- Subject** ▶ Change of Gear Complete and O Ring,
Reduction of Makita Grease
- For Models** ▶ HP2050, HP2050F, HP2051, HP2051F
- Country** ▶ All countries
- Description** ▶ Gear complete and O ring have been changed as illustrated below.
At the same time, the amount of Makita Grease in Gear housing complete has been reduced.

Change of Gear Complete

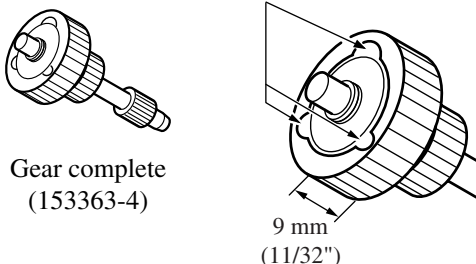
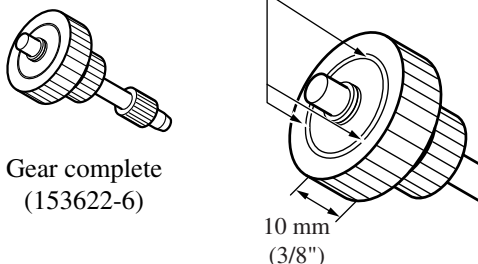
▶ Current	▶ New
<p>Hollows at each point along the circle.</p>  <p>Gear complete (153363-4)</p> <p>9 mm (11/32")</p>	<p>No hollow</p>  <p>Gear complete (153622-6)</p> <p>10 mm (3/8")</p>

Change of O Ring for Change Lever B

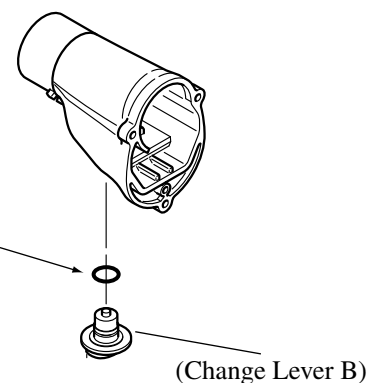
▶ Current	▶ New
 <p>O Ring 14 (213162-7)</p>	 <p>O Ring 12 (213122-9)</p>
